Access Compliance Report

Public Rights-of-Way

Intersection ID: 8855	Main Street: FREEDOM_DR	Cross Street: GAMBIA_ST	Location:	W
ADA ID: 27B74A0F7C77	Ramp Type: Perp	Initial Pass/Fail: Fail	Overall Compliance: No	Severity Score: 10

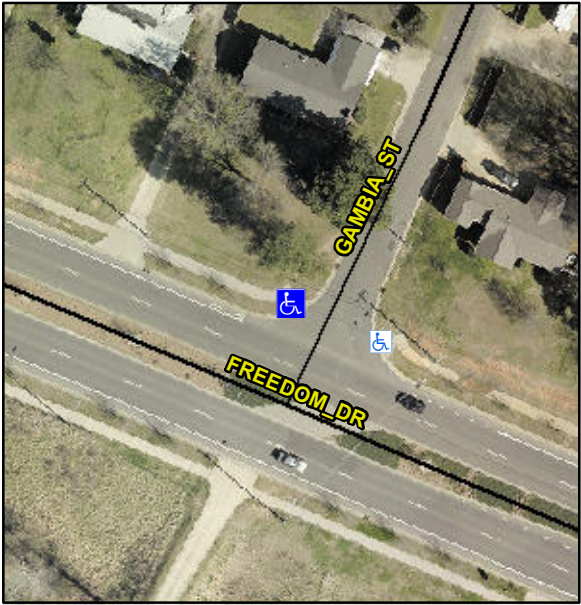
Codes/Mitigation Info/Possible Solution			Field Measurements/Component Compliance			
	Possible Solutions:		Compliance	Description	Data	
	Remove & Replace Entire Ramp.		N/A	Ramp Length (in)	85.0	Yes
			No	Ramp Width (in)	47.0	No
			N/A	Flare Type LT	N/A	N/A
			N/A	Flare Slope LT (%)	N/A	N/A
			N/A	Flare Traversable LT?	N/A	N/A
			N/A	Landing Length (in)	N/A	N/A
			N/A	Landing Width (in)	N/A	N/A
			N/A	Landing Slope (%)	N/A	N/A
			N/A	Landing X Slope (%)	N/A	N/A
Surveyor Notes: N/A PROW/ADA: Not Found, R304.5.1, R304.5.3			N/A	Flare Type RT	N/A	N/A
			N/A	Flare Slope RT (%)	N/A	N/A
			N/A	Flare Traversable RT?	N/A	N/A
			N/A	DWS Provided?	N/A	N/A
			N/A	DWS Contrast?	N/A	N/A
			N/A	DWS Length (in)	N/A	N/A
			N/A	DWS Full Width?	N/A	N/A
			N/A	DWS Offset (in)	N/A	N/A
			N/A	Gutter Ponding?	N/A	N/A
			N/A	Gutter Lip Ht (in)	N/A	N/A
Total Cost: \$ 1850.00			No	Painted X Walk1?	N/A	N/A
				X Walk 1 Direction	To SE	N/A

N/A	X Walk 1 Width (in)	N/A	N/A
				X Walk 1 Slope (%)	3.5	N/A
				X Walk 1 X Slope (%)	0.6	N/A
			N/A	Ramp inside XWalk1?	N/A	N/A
			N/A	Road Slope (%)	N/A	N/A
			N/A	Road X Slope (%)	N/A	N/A
			N/A	Any Obstructions?	N/A	N/A
				Obstruction Type		N/A
			N/A			N/A
			Yes	Surface Condition? (G/P)		Good
